1、2011.6.13 R4改为10k usb限流保护

Title		
MST6M181VS DEMO BOARD		
Size A2	Document Number MST6M181VS	Rev 1.0
Date:	Wednesday, July 06, 2011	Sheet 5 of 9

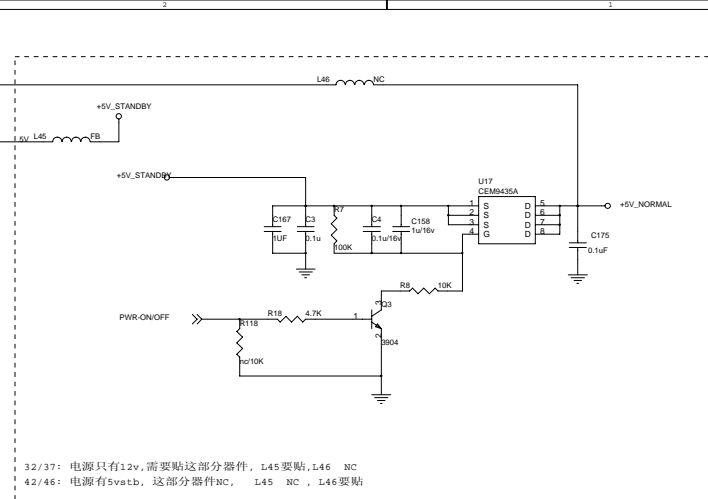
2011.6.17
1、功放增益由10改为01，减小底噪声
R96、R97 NC； 增加R23 、R115
2、IR 上拉重复， 删掉主板的R1159， 接收板上拉改10k

2011.7.7
HDMI 部分有1TE6633改为ps331

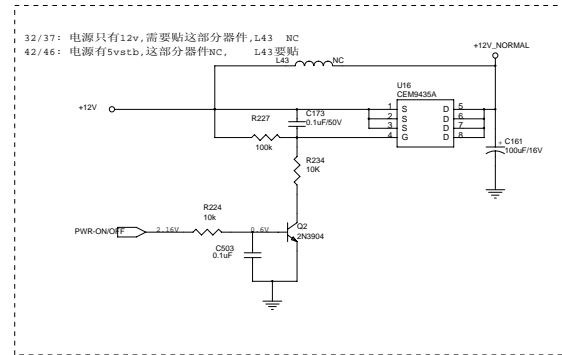
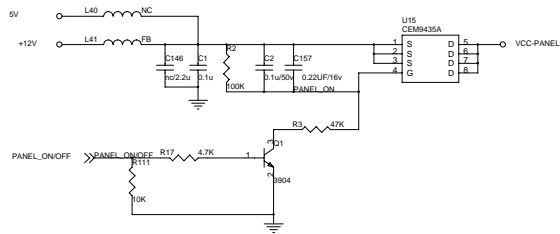
当电源有5VSTB时，应删除L45和Q48,Q47部分电路
增加L43，L46
